Title - Sujet PeSakastew Parking Lot Expansion	
Solicitation No. - N° de l'invitation EW038-160303/A	Amendment No. - N° modif. 003
Client Reference No. - N° de référence du client csc EW038-160303	Date 2015-06-26
GETS Reference No. - N° de référence de SEAG PW-\$PWU-183-10461	
File No. - N° de dossier PWU-5-38044 (183)	CCC No./N° CCC - FMS No./N° VME
Solicitation Closes - L'invitation prend fin at - à 02:00 PM on - le 2015-07-10	Time Zone Fuseau horaire Mountain Daylight Saving Time MDT
F.O.B. - F.A.B. Plant-Usine: <input type="checkbox"/> Destination: <input type="checkbox"/> Other-Autre: <input type="checkbox"/>	
Address Enquiries to: - Adresser toutes questions à: Tikhonovitch (RPC), Alex	Buyer Id - Id de l'acheteur pwu183
Telephone No. - N° de téléphone (780) 497-3541 ()	FAX No. - N° de FAX (780) 497-3510
Destination - of Goods, Services, and Construction: Destination - des biens, services et construction:

Addendum # 1

Subject	Pe Sakastew – Tender Addendum Items
---------	-------------------------------------

Addendum Items:

OVERALL SITE PLAN

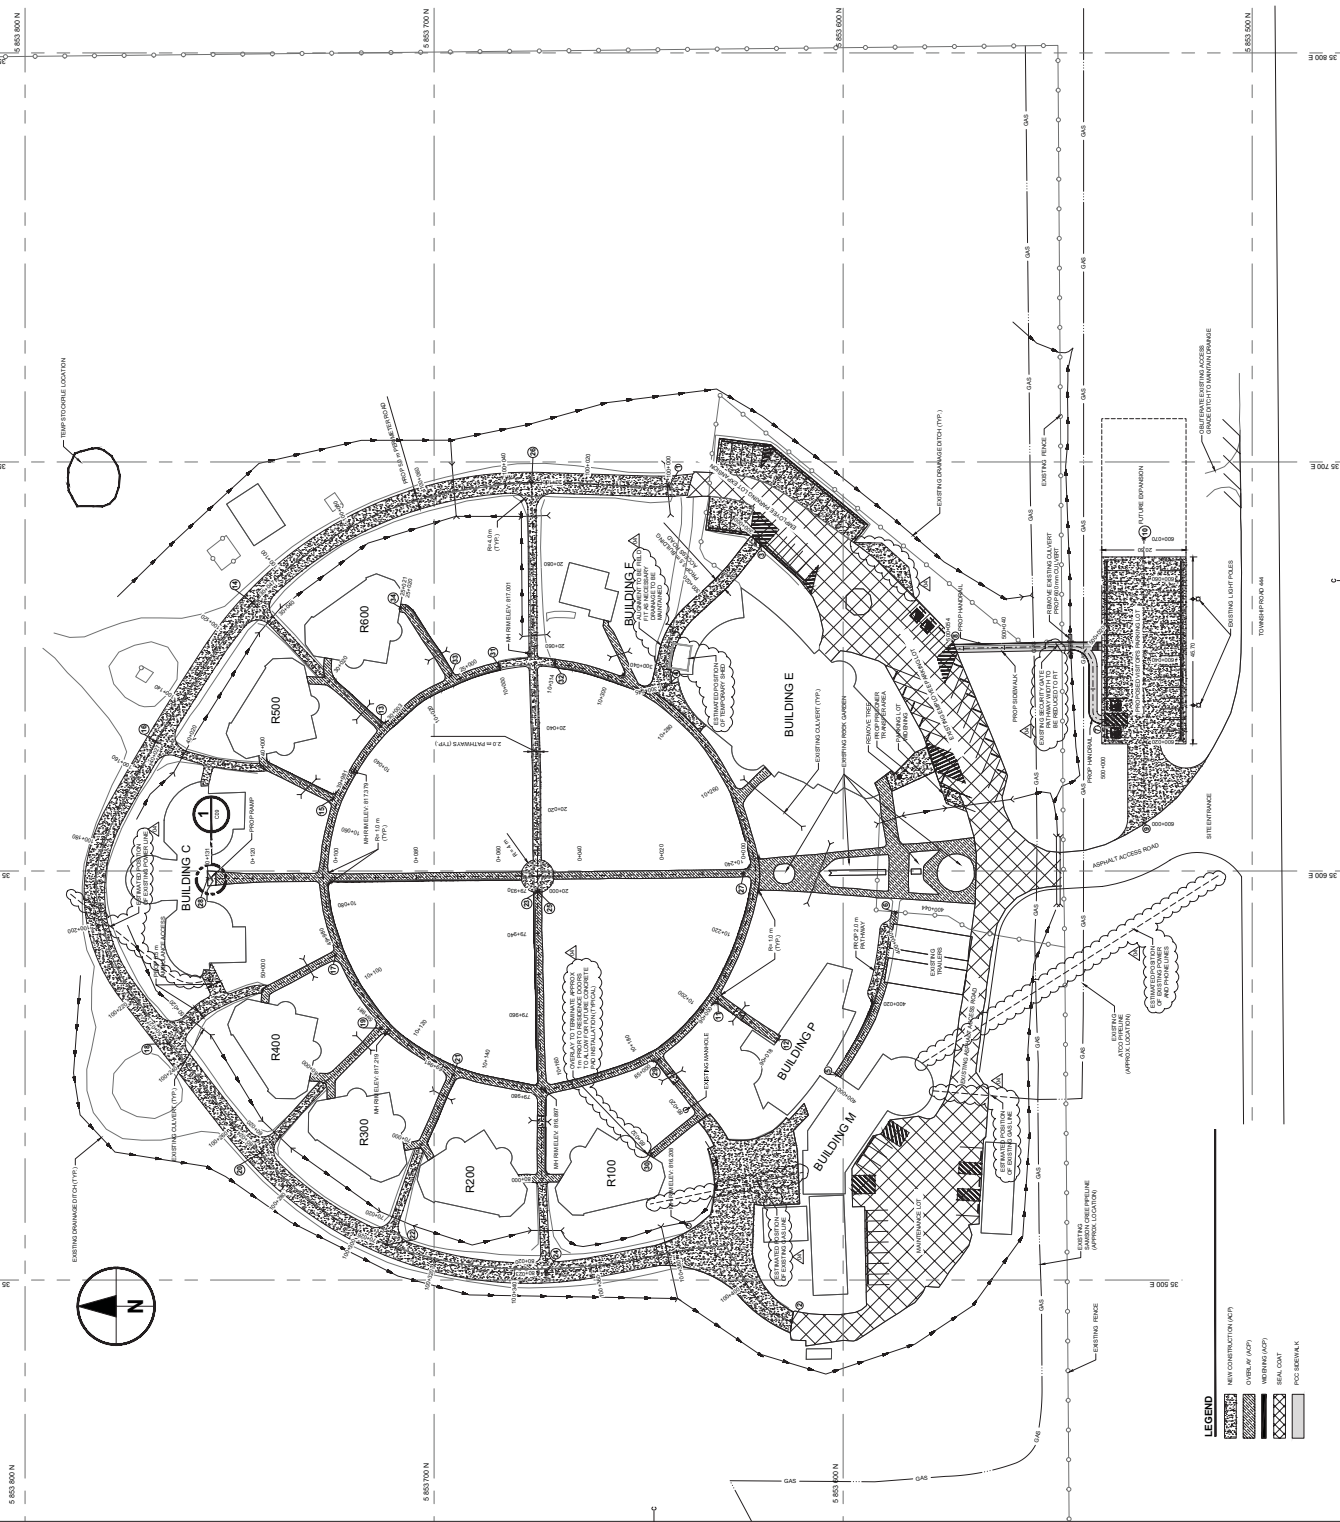
7. Final alignment for the proposed 3.5 m Building Access Road from Employee Parking Lot to be field adjusted to deviate around existing temporary maintenance shed. As indicated on revised drawing C02. Replace existing Drawing C02 with the attached & Updated Drawing C02

Sender	PMWSC Project Manager	Administrateur de projets PMWSC	no. du projet	no. du dessin
			R.061945.001	DWG C08

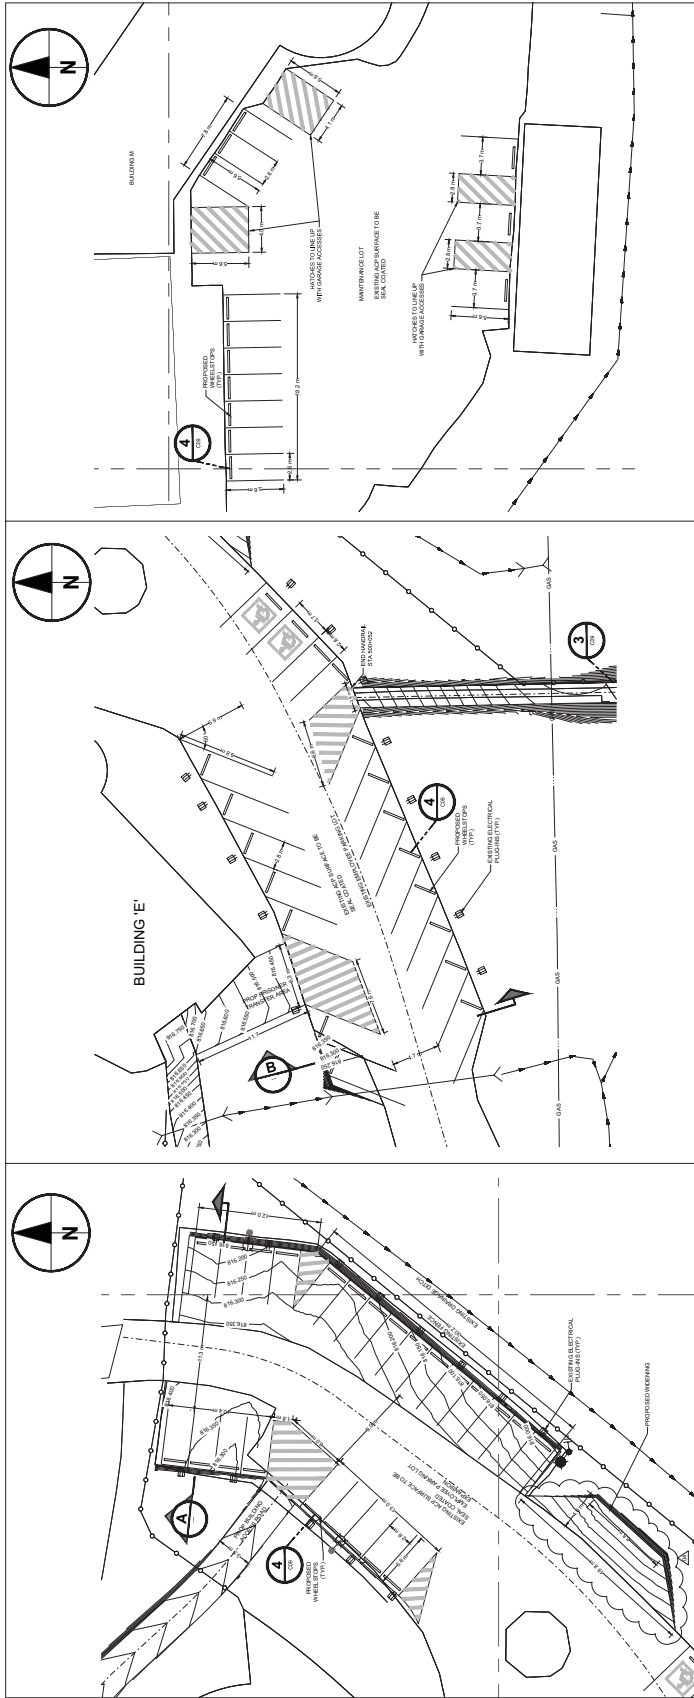
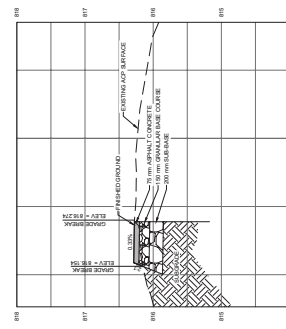
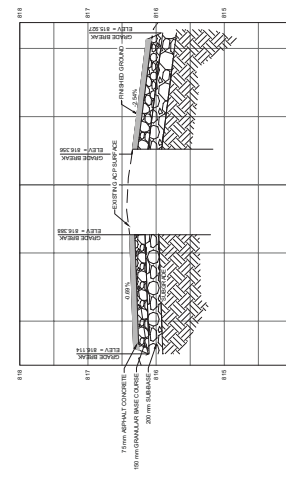
8. Dimension of proposed turn-around pavement widening adjusted as per revised drawing C08. Replace existing Drawing C08 with the attached & Updated Drawing C08
